Change Order

Change Order No.: 18 CBCL Project No. 241016.00
Date: January 27, 2026
To: Alex Sawyer – Harbour Construction
Contract Name: Mahone Bay Edgewater Street Improvements
Contract No.: 241016.00
Refer To: Harbour Quotation Document & SI-08
Copies To: Dylan Heide (Town of Mahone Bay)

Project Name:	Town of Mahone Bay Edgewater Street Improvements	Project No.:	241016.00
Contract:	Contract No. 241016.00	Contract No.:	241016.00
SI No.:	08	Date:	August 25, 2025
Refer To:	IFC- Rev 1 Drawings dated April 1, 2025		
Copies To	Alex Sawyer (Harbour Construction); Dylan Heide (Town of Mahone Bay)

Date AUG 21/2025	Scale AS NOTED	Designed SG	Drawn MF/DS	Checked LO'K/JK	Approved AB	CBCL No. 241016.00	Contract -
		EDGEWATER STREET IMPROVEMENTS					Drawing ESK06
		LIFT STATION LS05 GROUNDING

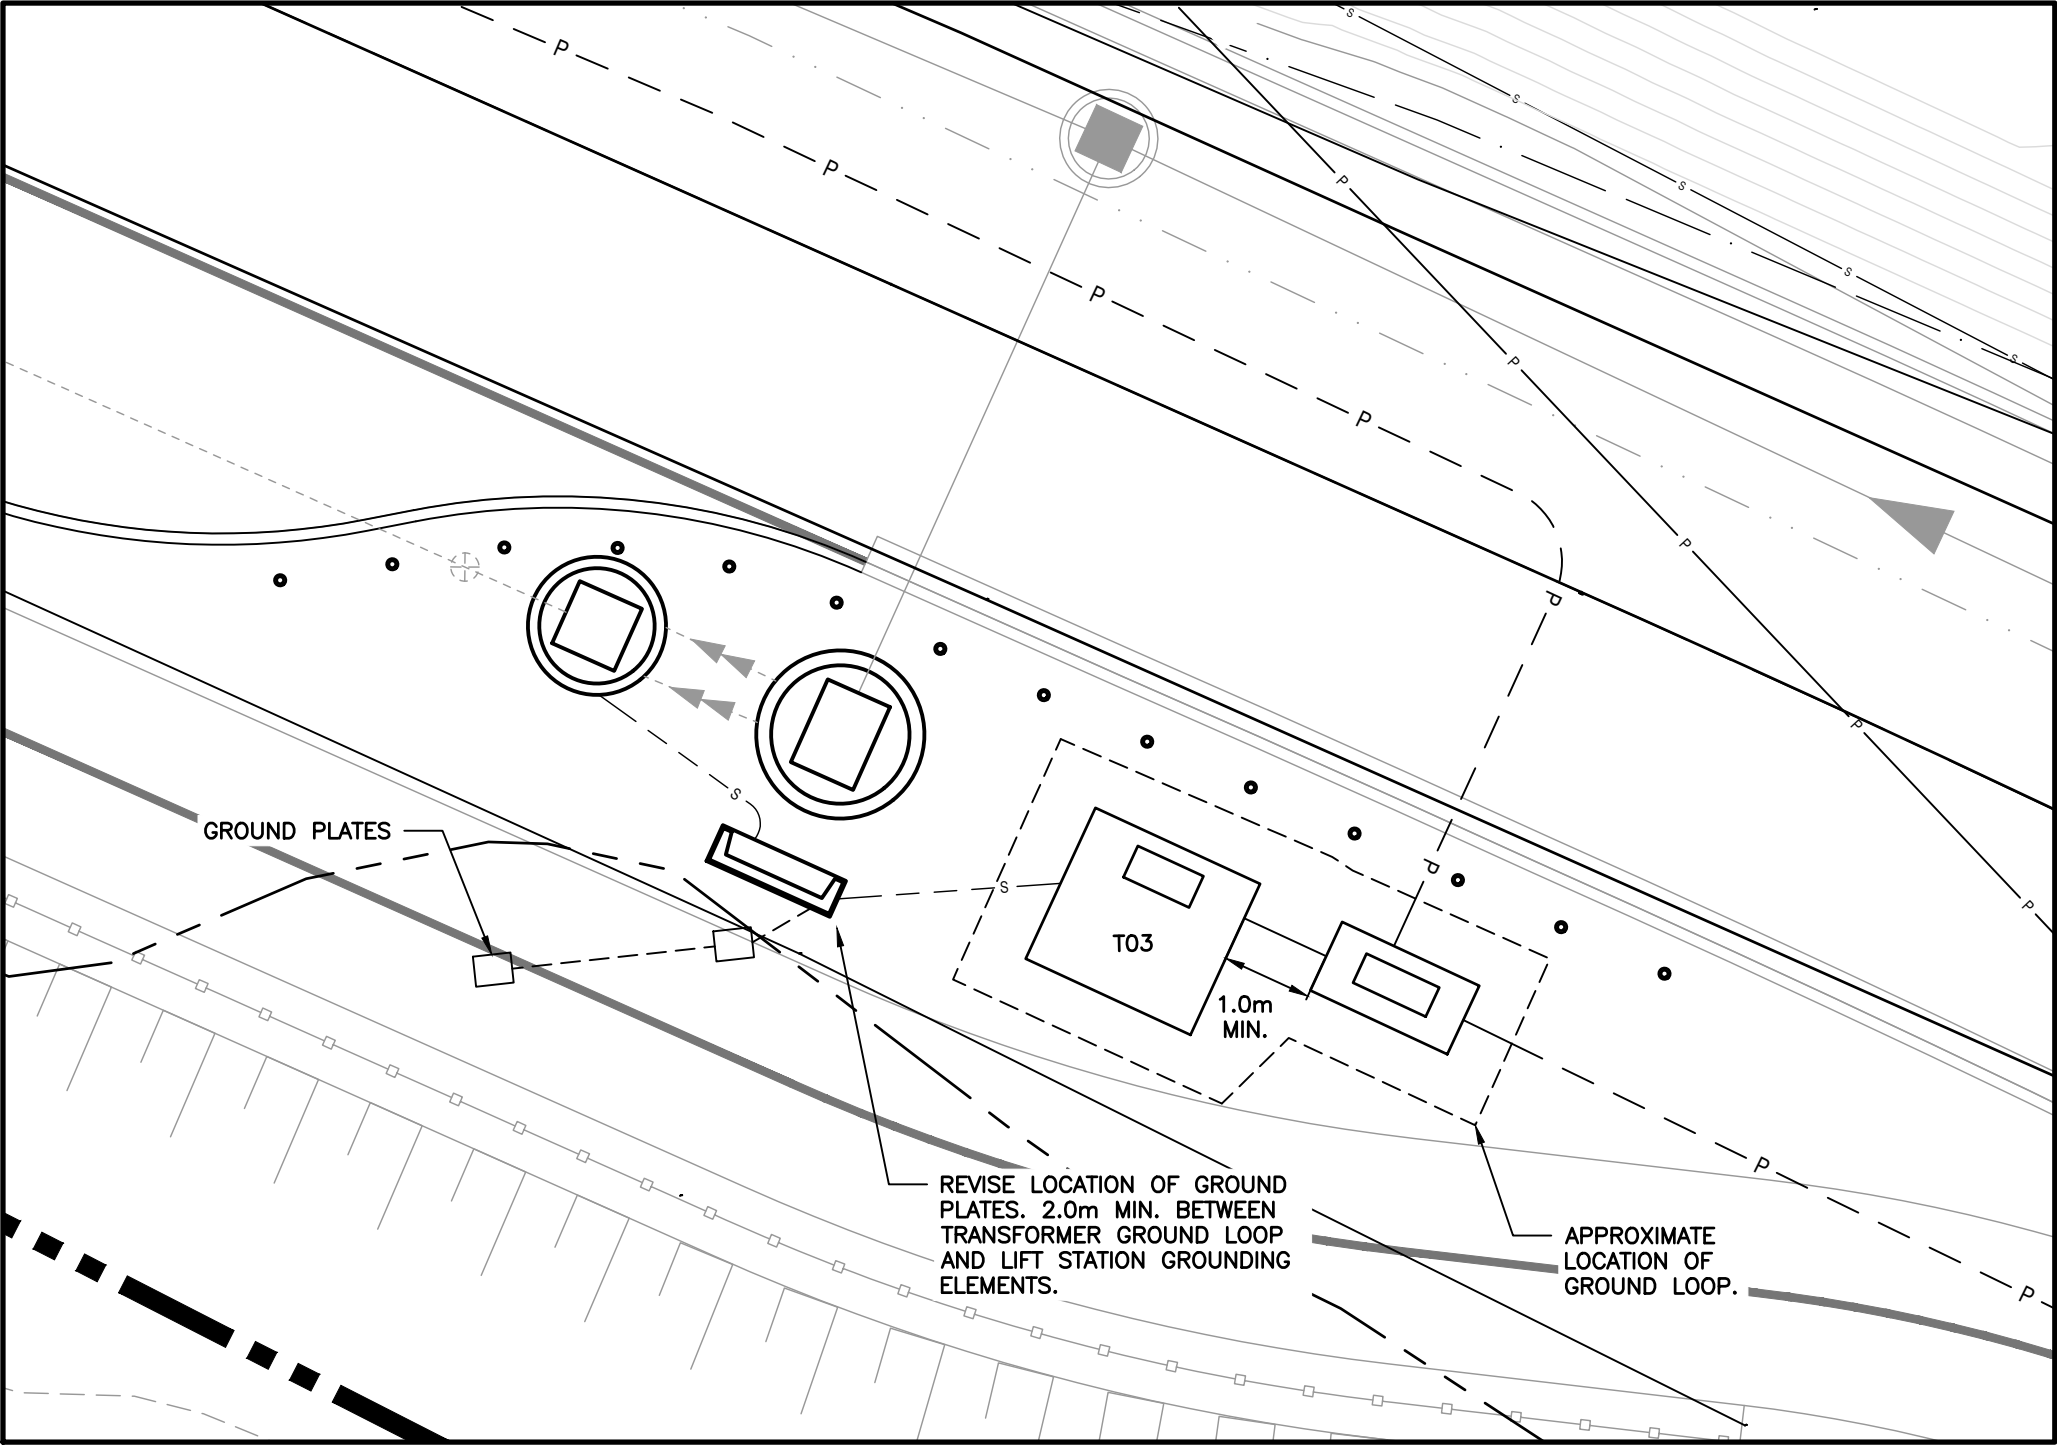
- Revise ground plate arrangement at Lift Station LS05 per attached **ESK06**.
